U.S. Department of the Interior BUREAU OF LAND MANAGEMENT Sundry Print Report

Well Name: HAWK 9I FEDERAL Well Location: T18S / R27E / SEC 9 / County or Parish/State: EDDY /

Type of Action: Plug and Abandonment

Permanent Abandonment of Federal Wells Conditions of Approval

HAWK 9 I FEDERAL #13 Plugging Procedure

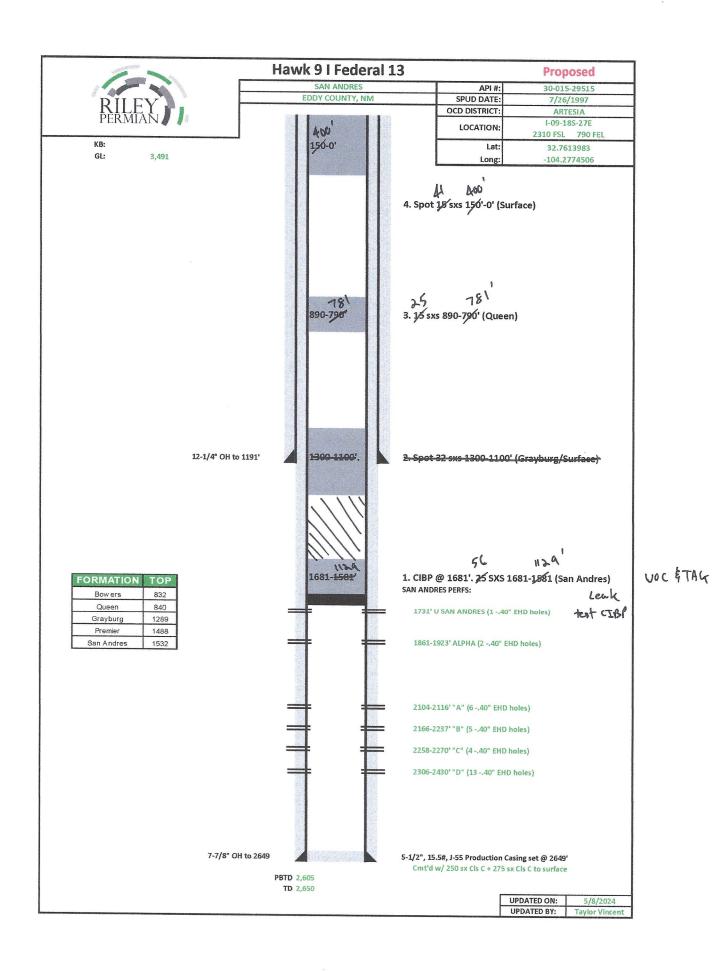
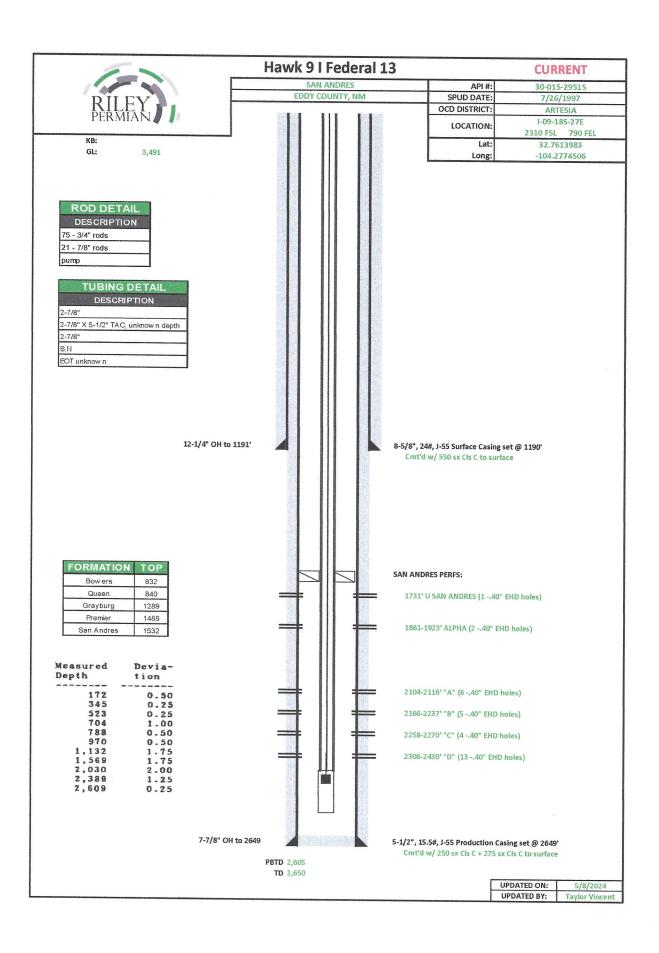
- 1. MIRU Rig and CMT Equipment. Check Anchors if not using Basebeam.
- 2. ND WH, NU BOP (Function Test)
- 3. POH w/Production
- 4. RIH w/HM Plug to 1681'. Load Hole w/9.5# MLF. Plug #1 28'SXS 1681-1581'. Loak test CIGP, UOC FTAK
- 5. LD TBG to 1300'. POH w/TBG. RUWL. CBL to Surface. (*)
- 6. RIH w/TBO': Plug #2 32 SXS 1300-1100': (Surface/Grayburg)
- 7. LD TBG to 890'. Plug #3 15 SXS 890-790'
- 8. LD TBG to 150'. Plug #4 15 SXS 150-0'.
- 9. RDMO PU, Transport trucks, and equipment. Cut off WH 3' below ground level & Install dry hole marker. Cut off anchors

Tag, Leak			
				Test all			Set CIBP at 1681'.
				CIBP if no			Leak test CIBP.
				Open			Spot cement from
CIBP Plug	1646.00	1681.00	35.00	Perforatio	56.00	C	1681' to 1129'. WOC and Tag.
Perforations Plug (If No CIBP)	1681.00	2480.00	799.00	Tag/Verify	55.00		vvoo and ray.

Created B	Condition	Condition Date
gcorder	Plugging approved per BLM approved plugging plan. CBL must be submitted to OCD via OCD Permitting prior to submitting C-103P	8/15/2024
